**ADDENDUM NO. 1**  
**October 28, 2020**  
**225902**

**RE: TOWN OF JERICHO, VERMONT**  
**JERICHO EWP 5038-007**  
**DRY LAID STONE MASONRY WALL RESCONSTRUCTION**

**FROM: DDK ENGINEERING-JV**  
28 North Main Street  
Randolph, Vermont 05060  
(802) 728-3376

**PROPOSED PLAN SHEET**

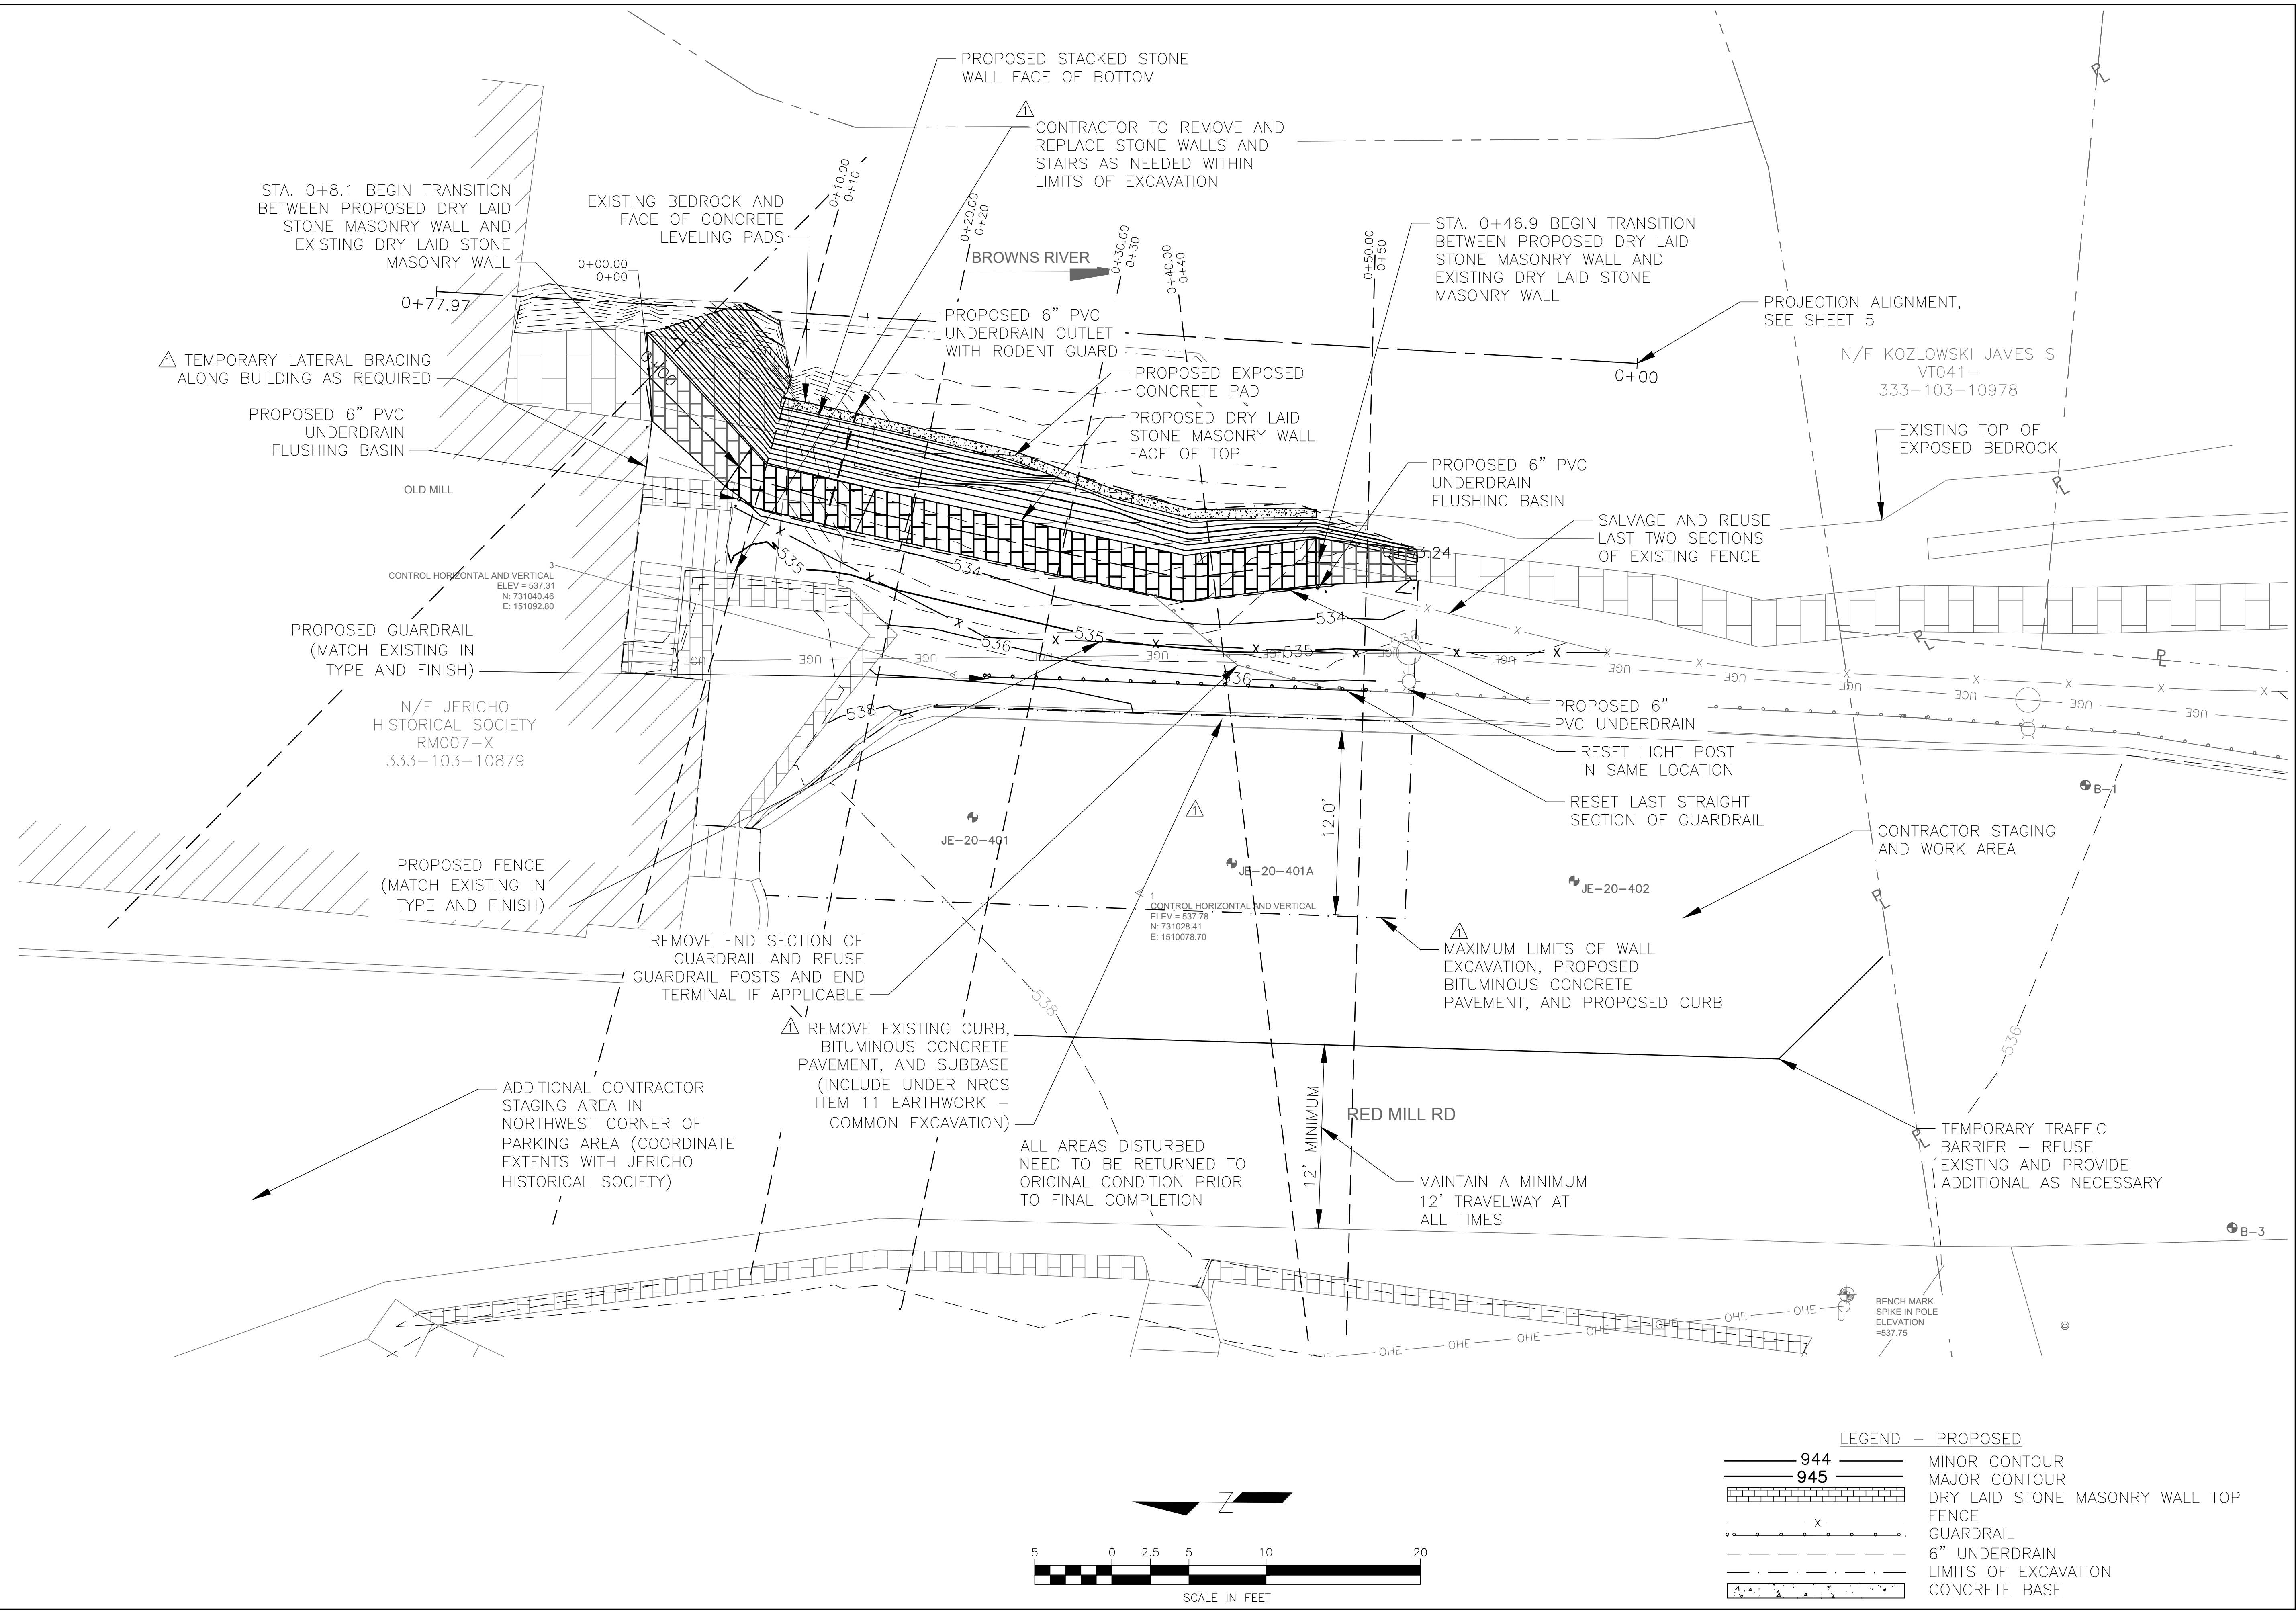
NO.	DATE	DESCRIPTION	BY	CK'D
1	10-27-2020	ROADWORK DETAILS, EXCAVATION LIMITS	KMF	GPH

DRY LAID STONE MASONRY WALL  
ELEVATION VIEW

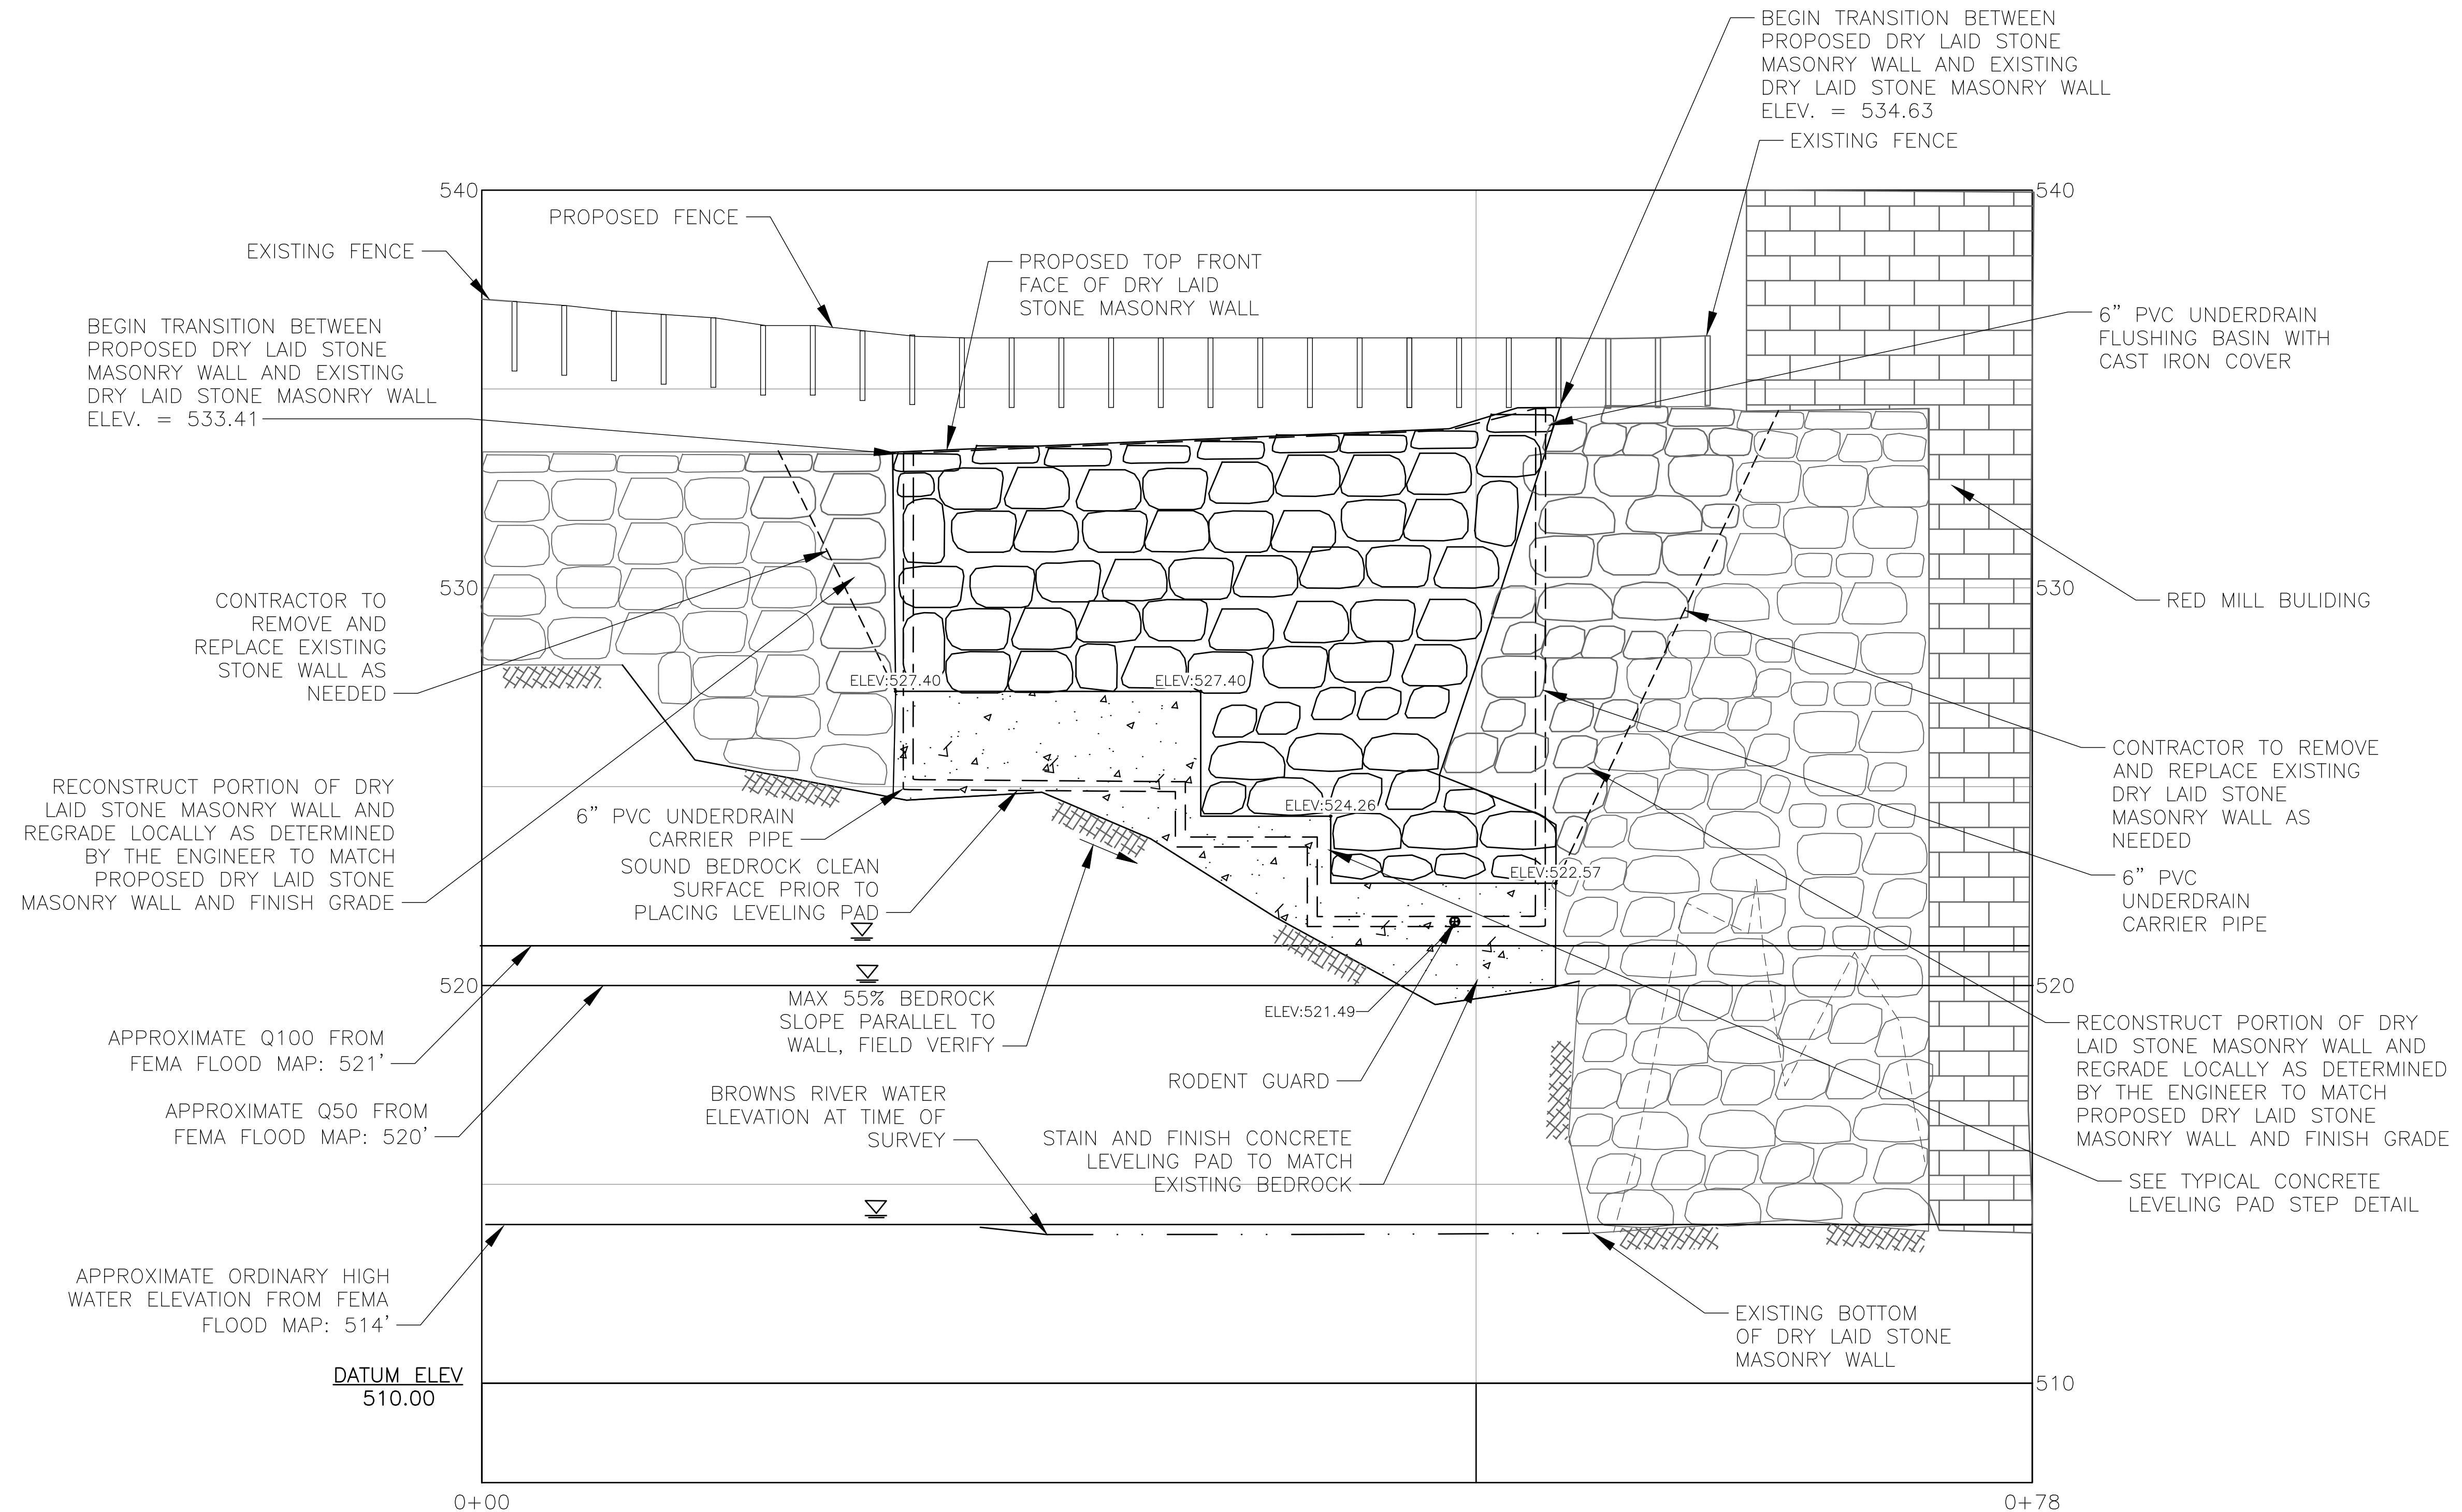
NO.	DATE	DESCRIPTION
1	10-27-2020	VERTICAL SCALE - ROADWORK DETAILS EXCAVATION LIMITS
2		
3		
4		
5		
6		
7		
8		
9		
10		
11		
12		
13		
14		
15		
16		
17		
18		
19		
20		
21		
22		
23		
24		
25		
26		
27		
28		
29		
30		
31		
32		
33		
34		
35		
36		
37		
38		
39		
40		
41		
42		
43		
44		
45		
46		
47		
48		
49		
50		
51		
52		
53		
54		
55		
56		
57		
58		
59		
60		
61		
62		
63		
64		
65		
66		
67		
68		
69		
70		
71		
72		
73		
74		
75		
76		
77		
78		
79		
80		
81		
82		
83		
84		
85		
86		
87		
88		
89		
90		
91		
92		
93		
94		
95		
96		
97		
98		
99		
100

1. DRY LAID STONE MASONRY WALL LEVELING PAD ELEVATIONS ARE BASED ON APPROXIMATION OF THE EXISTING BEDROCK PROFILE. THE DESIGN HEIGHT OF THE DRY LAID STONE MASONRY WALL SEGMENTS WERE DETERMINED BASED ON THE ELEVATIONS SHOWN. THE INTENT IS FOR THE CONTRACTOR TO PROVIDE THE PROPOSED FINISHED GRADE AS SHOWN IN THE ELEVATION.
